ADDENDUM

ADDENDUM NUMBER: One **DATE:** October 26, 2023

RE: NPHC Plaza
 Austin Peay State University
 SBC Project No. 373/003-03-2023

SITE PLAN & DETAILS

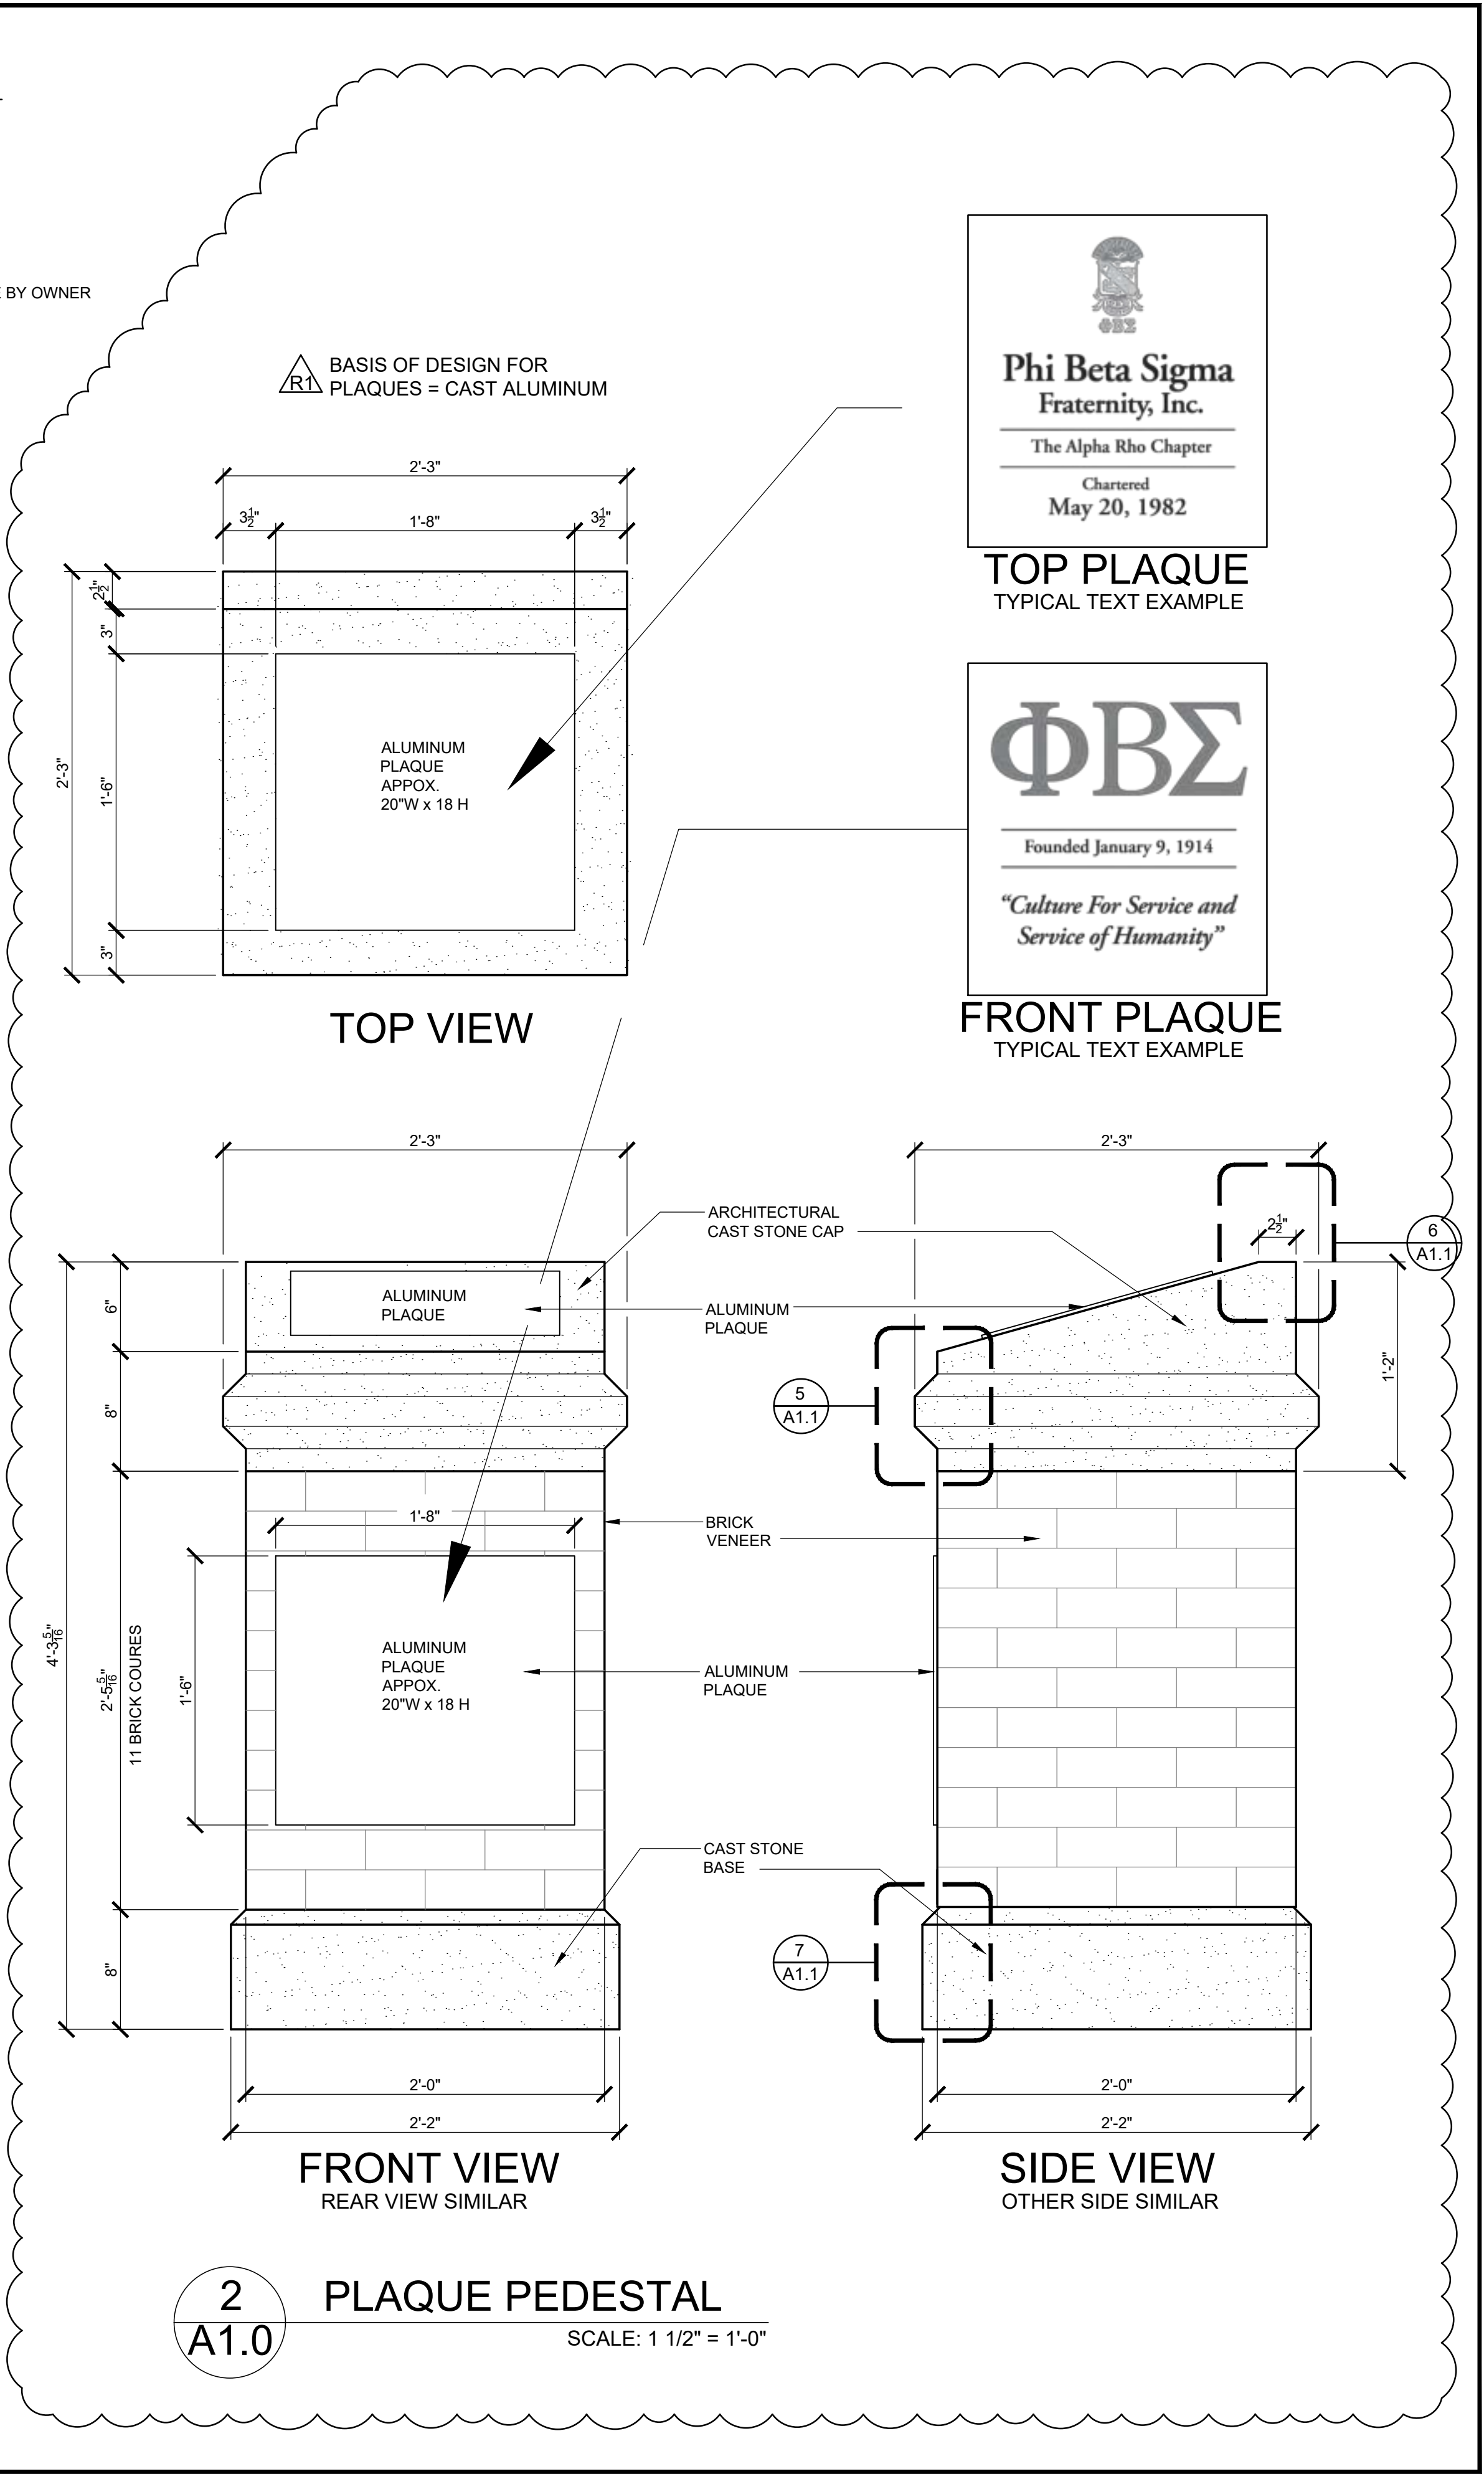
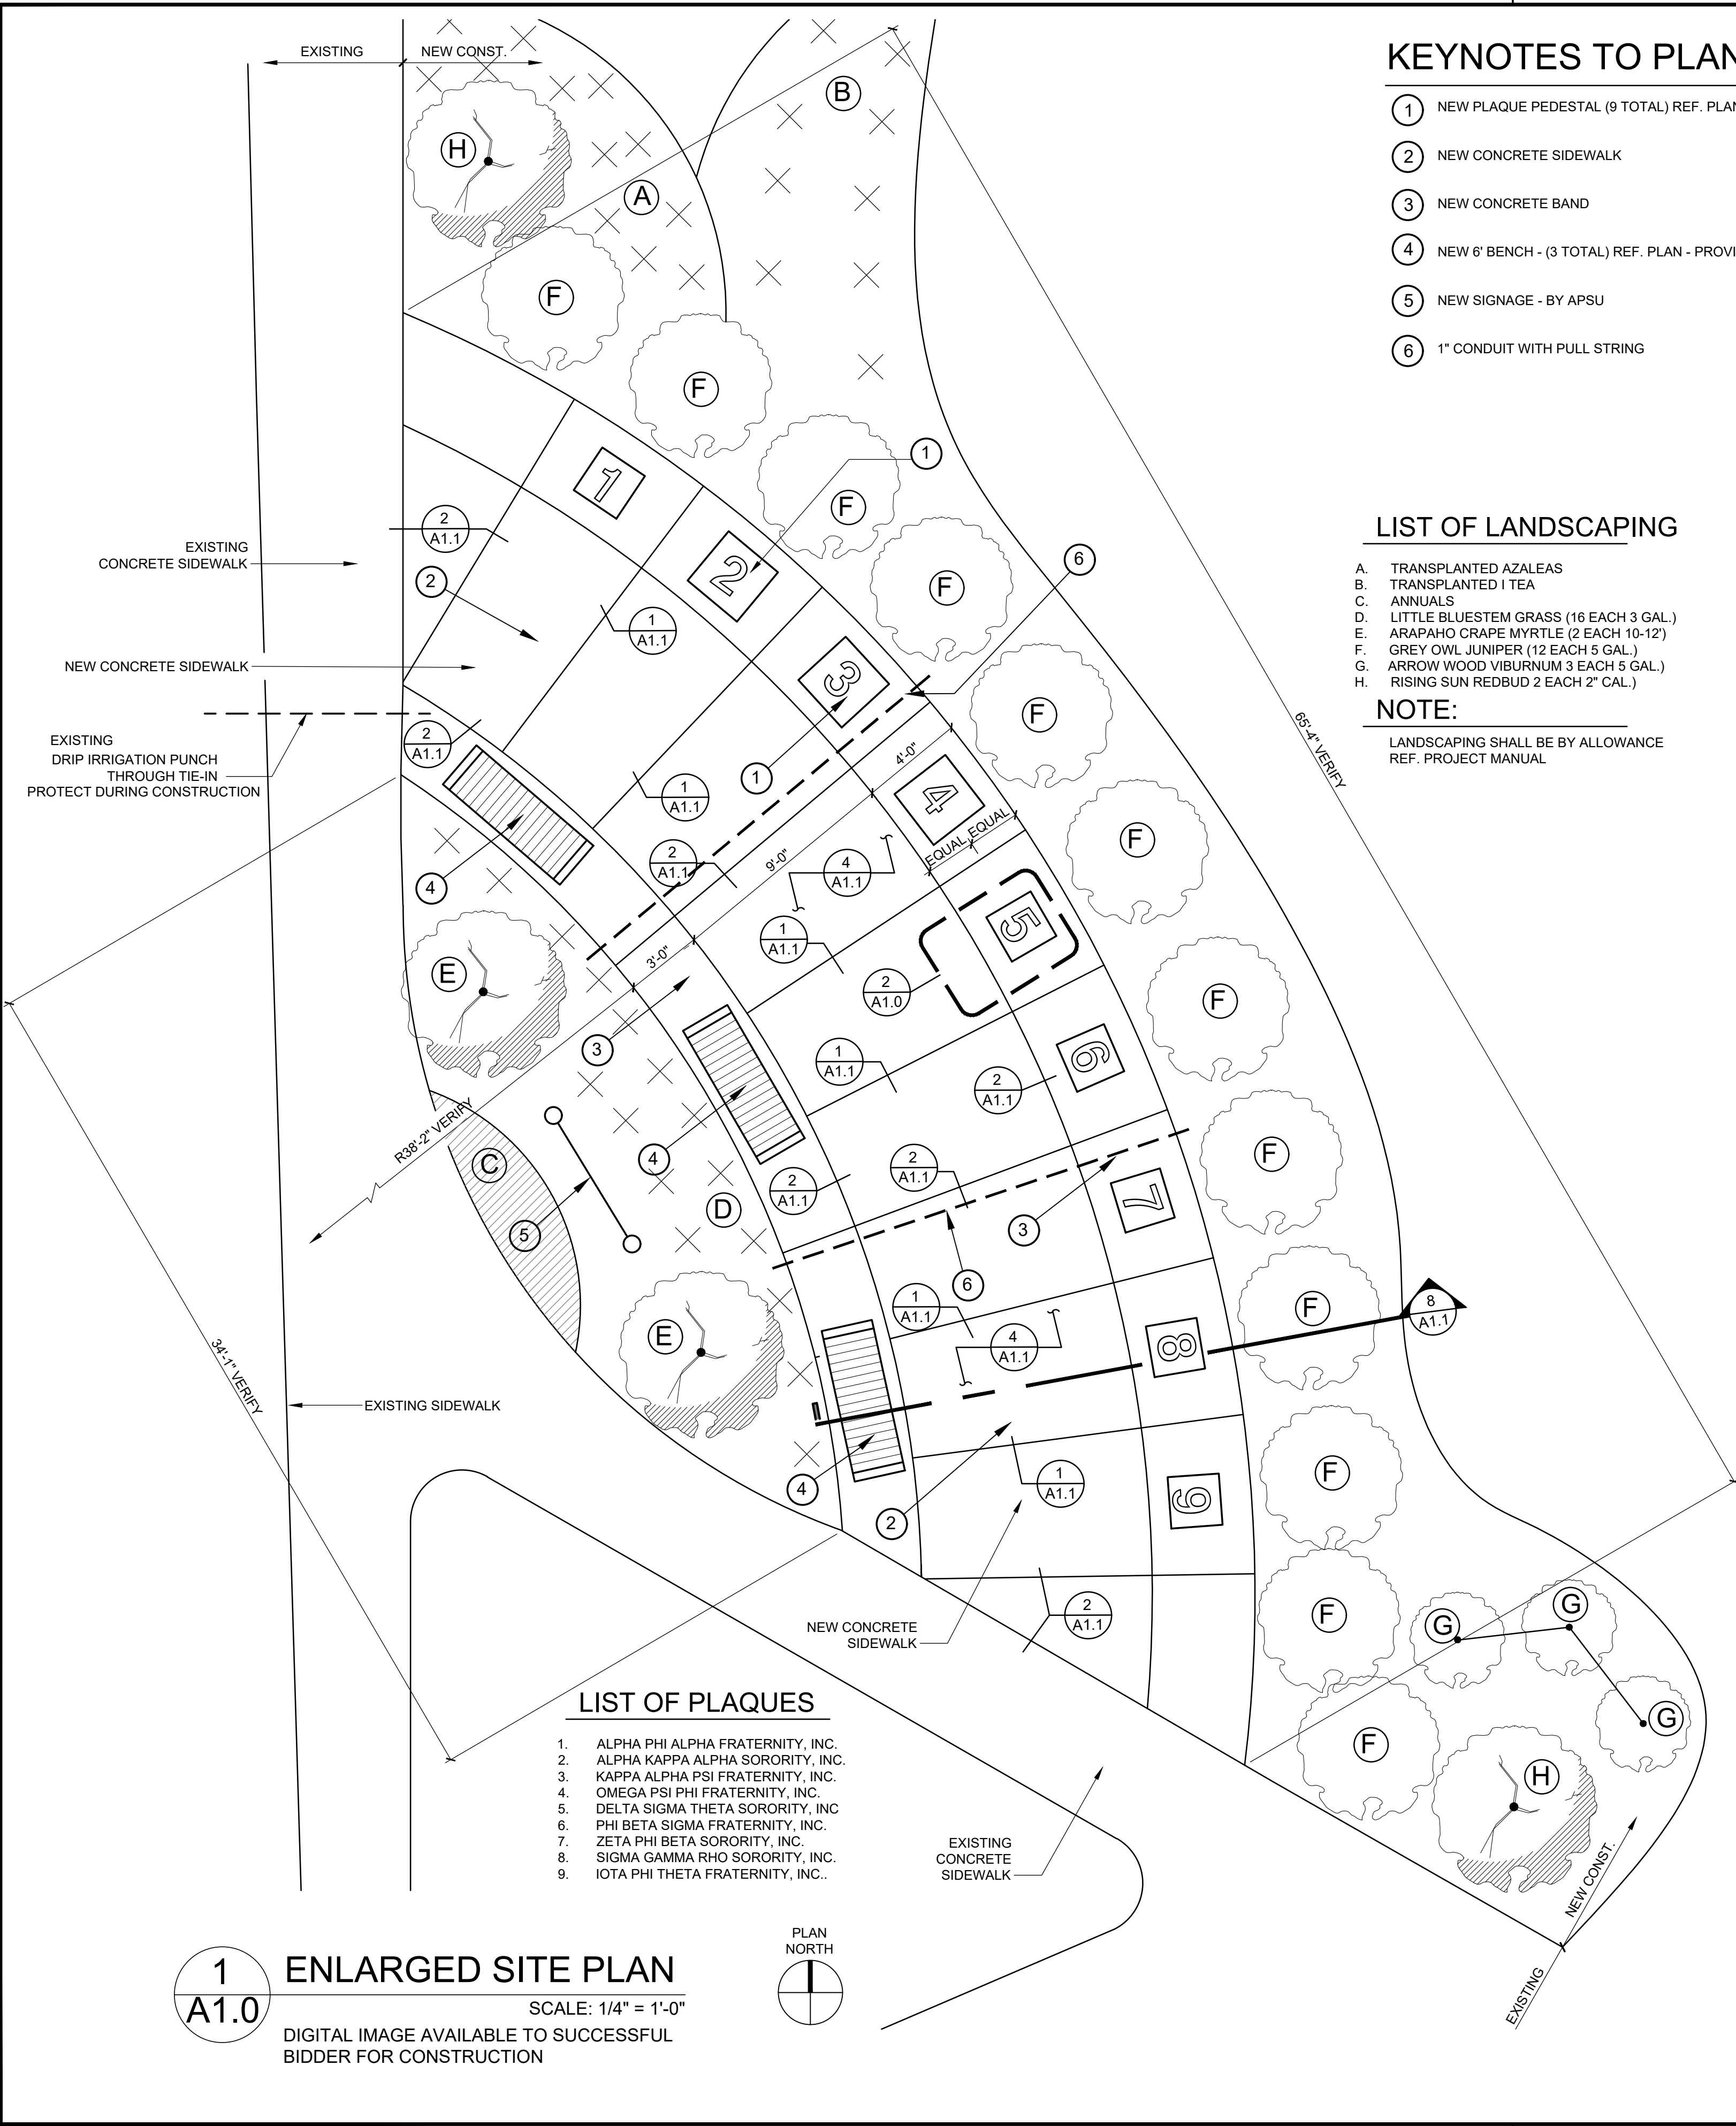
VI-1 Reference Sheet A1.0 Site Plan and Details, and Sheet A1.1 Details.
Delete original drawing sheets and replace with revised sheets A1.0 and A1.1. Revisions include: replacing originally specified bronze plaques with cast aluminum plaques as the Basis of Design.
